# Certificate of Appropriateness

**Property** 3034 W. STATE ST. Concordia Historic District

**Description of work** Correct violations as indicated below on violation notice and in manner indicated.

**Date issued** 10/29/2019 PTS ID 114880 COA: Correct violations

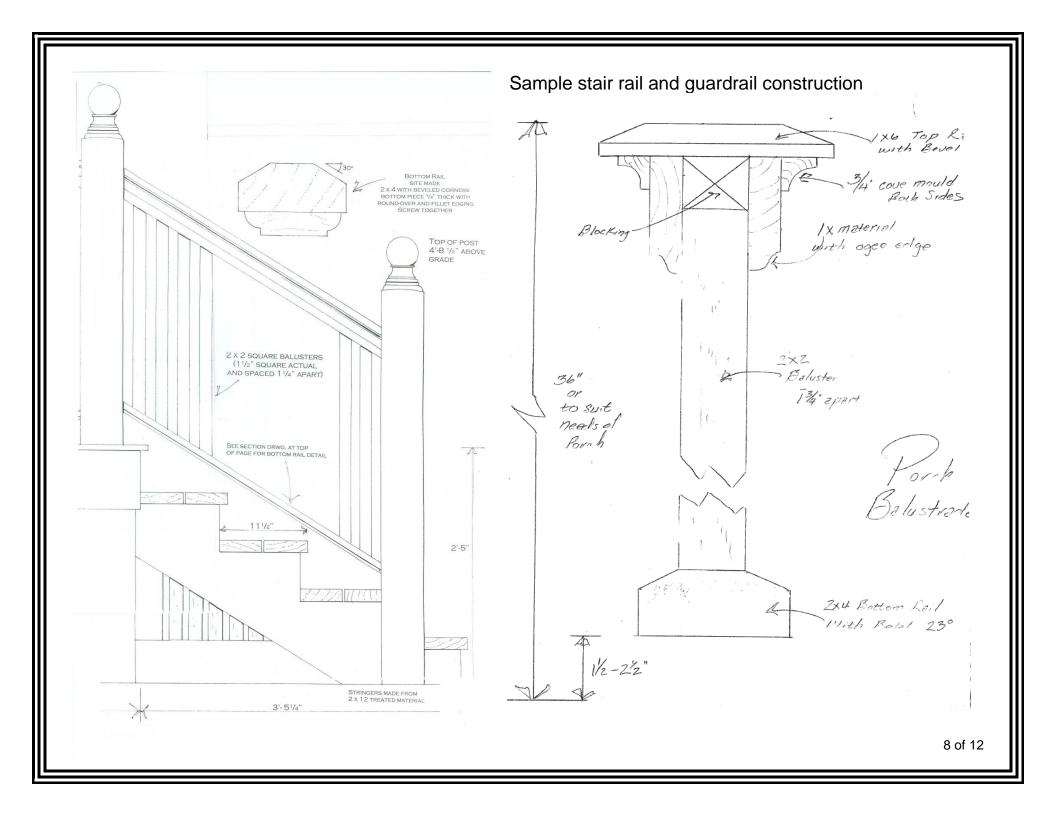
4) 275-32.3.g Provide an approved guardrail for porch. use cedar balusters to match Violation Location: South Side circled style on p. 182 of As Good As New

Balusters shall be a painted, naturally rot resistant wood species and painted. The same design shall be used to replace the stair railing at the east of the porch.

Photo c. 1980. New porch railing and stair railing shall be constructed of urn balusters similar to this design (at least 4x4" in size). See previous page.

**Violation Location: South Side**

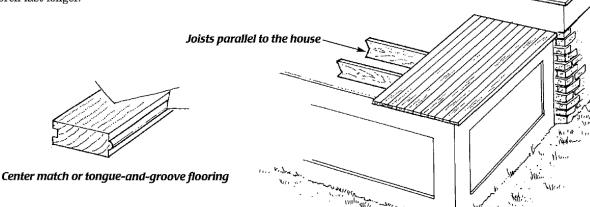
5) 275-32.3.g Replace defective porch floor boards and secure to supporting structure. New Natural wood lation Location: South Side Vouglas First or other hatural wood

Replace porch decking with new Douglas fir center-match flooring. Maximum acceptable board width is 5.5".

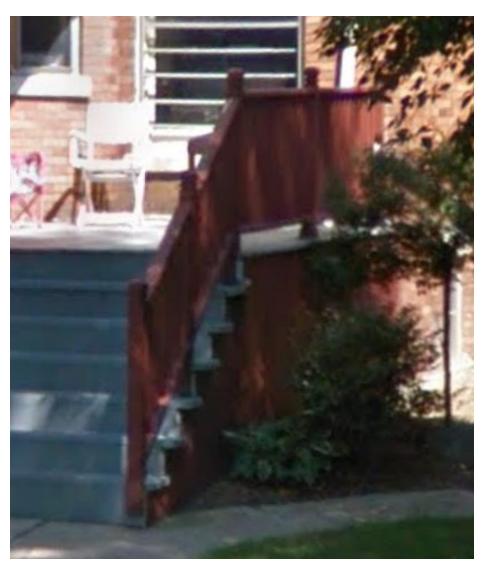
> 10 ) 275-32.3 Replace defective roofing material. Note: As required by 275-32-12, rolled roofing material shall

not be installed over any existing roofing material except existing rolled roofing. (Front porch)

Replace all of porch roofing materials with closest product available to match existing shingles on house's main roof. A list of potentially acceptable shingles has been provided separately.
